SOUTH AURORA PROPERTY INVESTORS, LLC.

PRONGHORN
PUBLIC IMPROVEMENT PLAN - EAST PARCEL

DATE	REVISION COMMENTS
4/8/2018	PER CITY COMMENTS

Table with columns: ISSUE DATE, DATE, PER CITY COMM, SHEET NO. 6

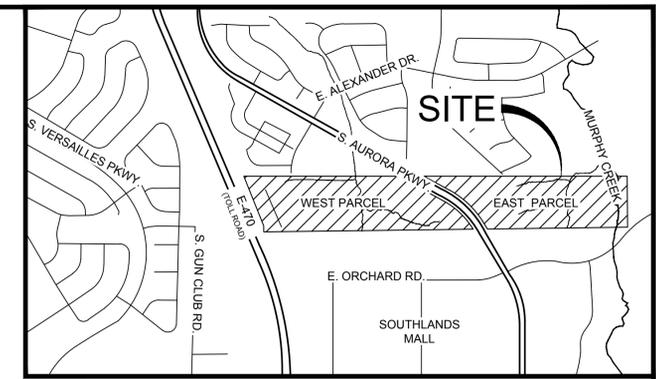
please use color to help illustrate the PIP. Colored hatches used to delineate planning areas.

revise to a T intersection given the new roadway layout. Revised to T intersection.

is a mini roundabout going to be constructed with planning area A? if so this should be identified in the narrative. Revised to T intersection, and no longer called out as ROW. T intersection to be constructed with the rest of this roadway improvement.

urban drainage shall determine if improvements are required to Tollgate. Urban Drainage has determined that no improvements are required to Tollgate.

Please combine the narrative with the exhibit for future submittals.

Per the May 3, 2018 meeting: Planning areas must be revised- it appears there are two logical planning areas, the multi-family west of Tollgate Creek and the commercial/mixed-use east of Tollgate Creek. Tollgate Creek improvements must be tied to a CO- this needs to be described in the narrative. Pedestrian Bridge: the narrative must clearly obligate the completion of the bridge for a specific planning area. Consideration should be given to an interim treatment allowing pedestrian access to Aurora Parkway if the commercial planning area does not come in first.

indicate opposing access point. Viewport expanded to show opposing access point.

on street parking should be provided. This street must be a local type 1 per traffic engineering comments in the Pomeroy FDP Amendment: Multi-Family Planning Area Meeting letter.

Please include a section for S Aurora Parkway to show the required improvements. Section included.

Bike lanes should be 7'. Off street bike access is preferred (10' min sidewalk instead of on street bike lanes). Roadway sections have been revised.

The PIP should include the narrative as required by the FDP manual. please revise the language to describe required improvements for each PLANNING AREA, anticipated phasing may be discussed, but Planning areas must be planned to develop in isolation of one another. Phasing notes have been removed from this plan and incorporated into the narrative.

improvements of creek should also occur with whichever side is developed first. Urban Drainage has determined that no improvements are required to Tollgate.

Construction of roadway is required for Planning Area B. Phasing notes have been removed from this plan and incorporated into the narrative.

is there an opportunity for street parking? perhaps at a minimum on the west side? Roadway sections have been revised.

Commercial areas utilize the Local Type 3 section with 40' flowline to flowline. 26' may not be sufficient. Roadway sections have been revised.

construction of roadway (Local Type 1) required for Planning Area A- cross access agreement to connect to South Southland's Parkway is required. There may be required improvement for Southland's Parkway to make this connection.

SOUTH AURORA INVESTORS, LLC. ensure planning areas are correctly identified. Phasing notes have been removed from this plan and incorporated into the narrative.

PRONGHORN INVESTORS, LLC. this is getting confusing, please specify east of Aurora Parkway. Phasing notes have been removed from this plan and incorporated into the narrative.

Narrative and plan combined.

Planning areas have been revised. Pedestrian bridge responsibility called out in narrative.

Roadway sections have been revised.

Phasing notes have been removed from this plan and incorporated into the narrative. Viewport expanded and additional linework shown to clarify off site improvements. We acknowledge that an agreement with Southlands will be necessary for off site improvements.

SHEET NO. **7**

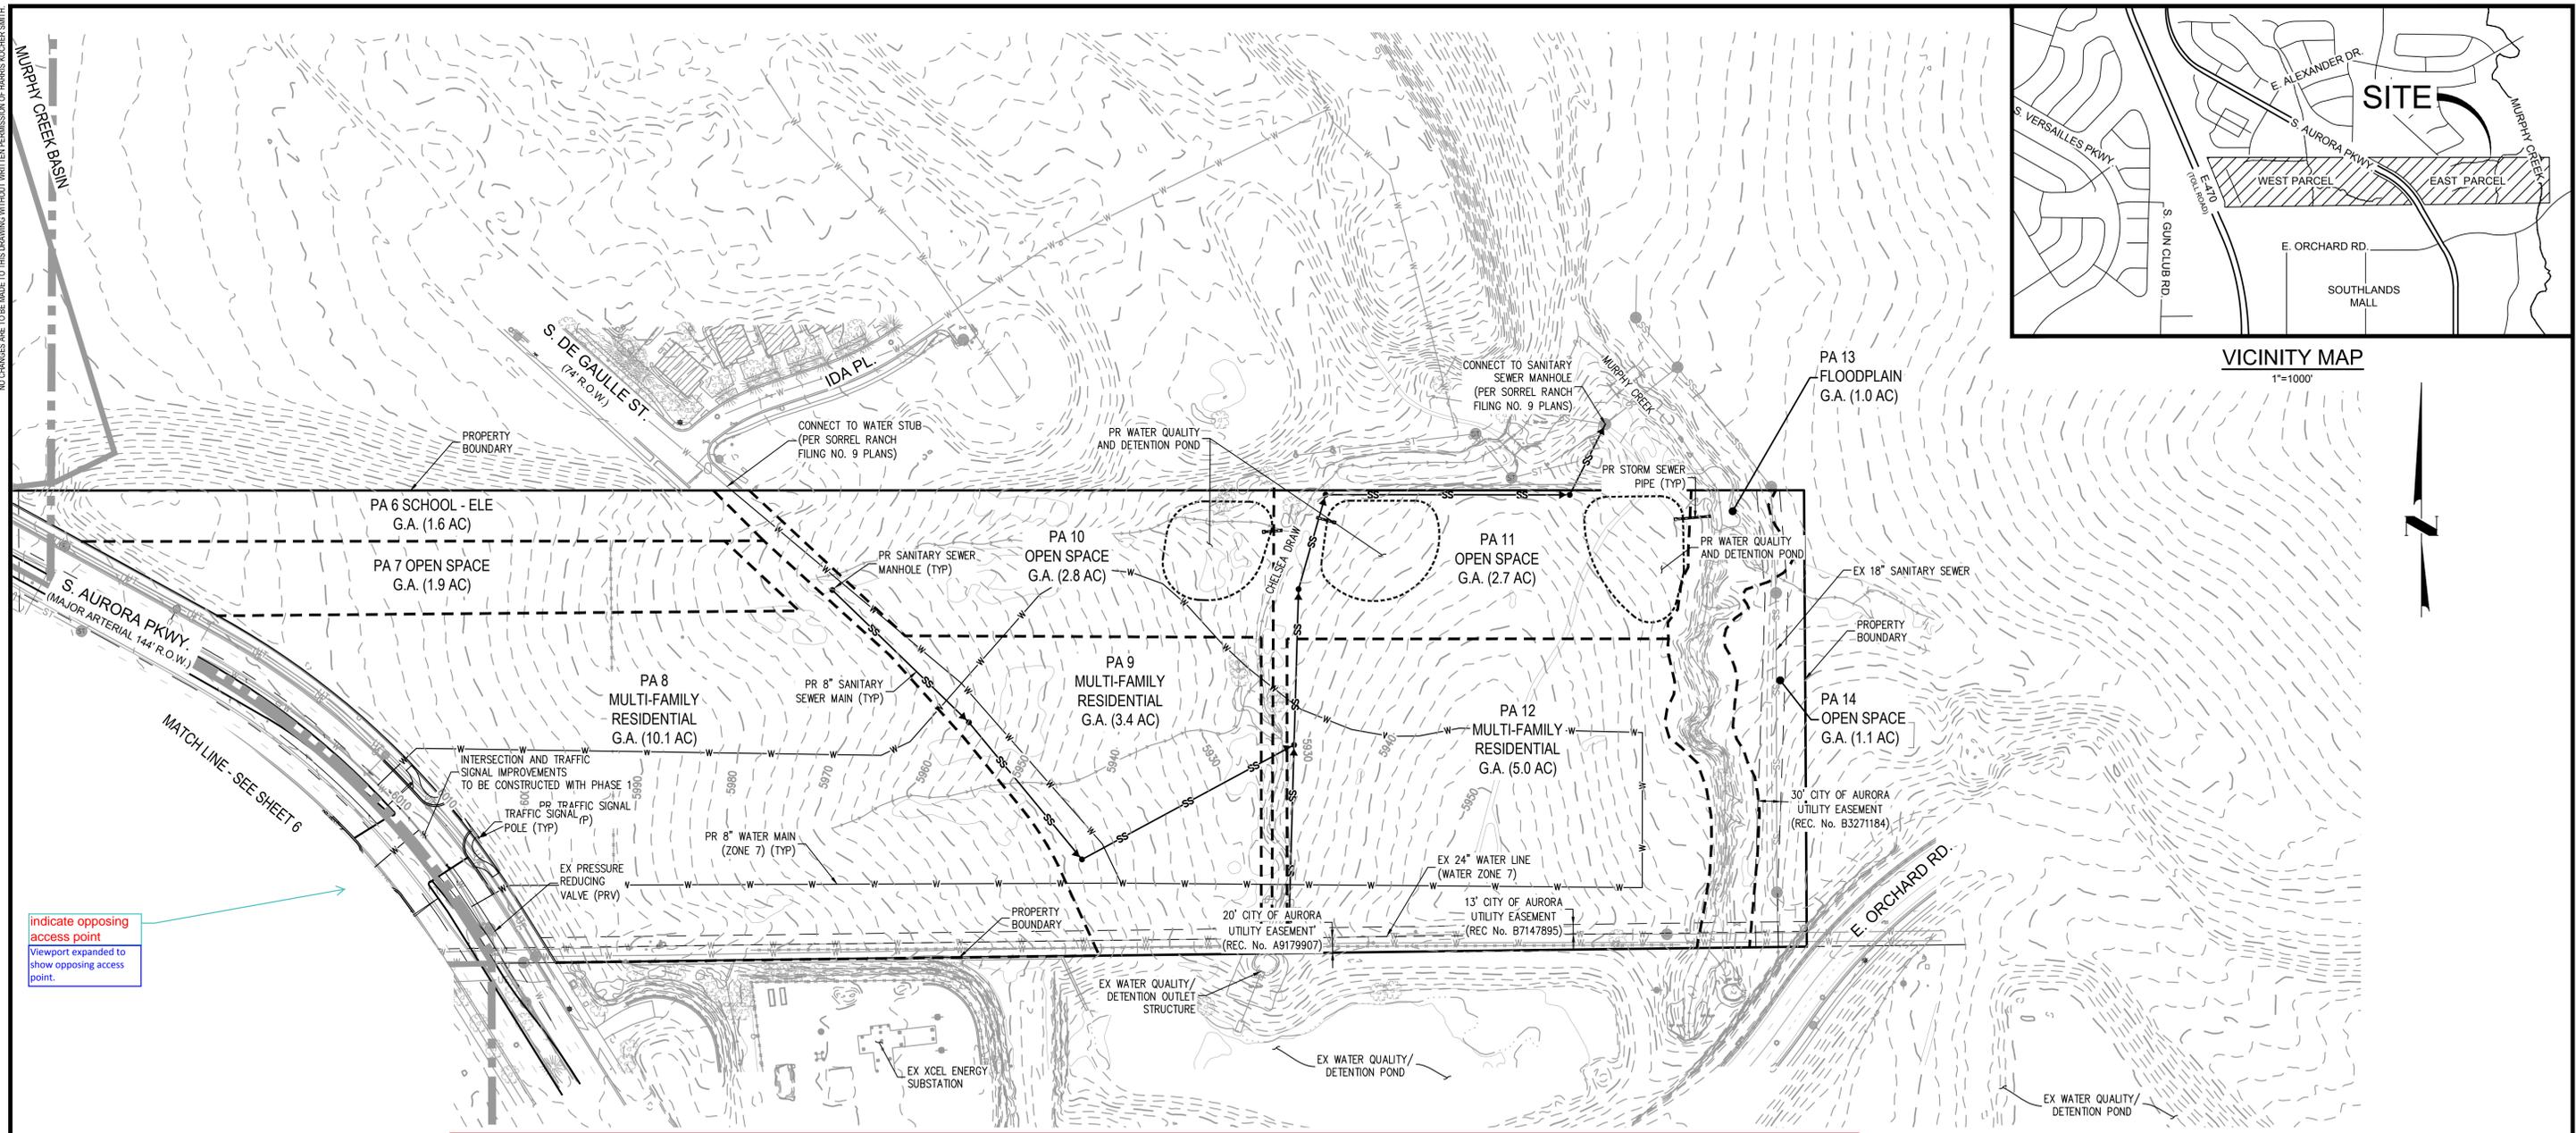
ensure planning areas are correctly identified. Phasing notes have been removed from this plan and incorporated into the narrative.

this is getting confusing, please specify east of Aurora Parkway. Phasing notes have been removed from this plan and incorporated into the narrative.

revise sheet count- there are only two sheets in this set. Corrected.

indicate opposing access point
Viewpoint expanded to show opposing access point.

these notes are repeating
Phasing notes have been removed from this plan and incorporated into the narrative.
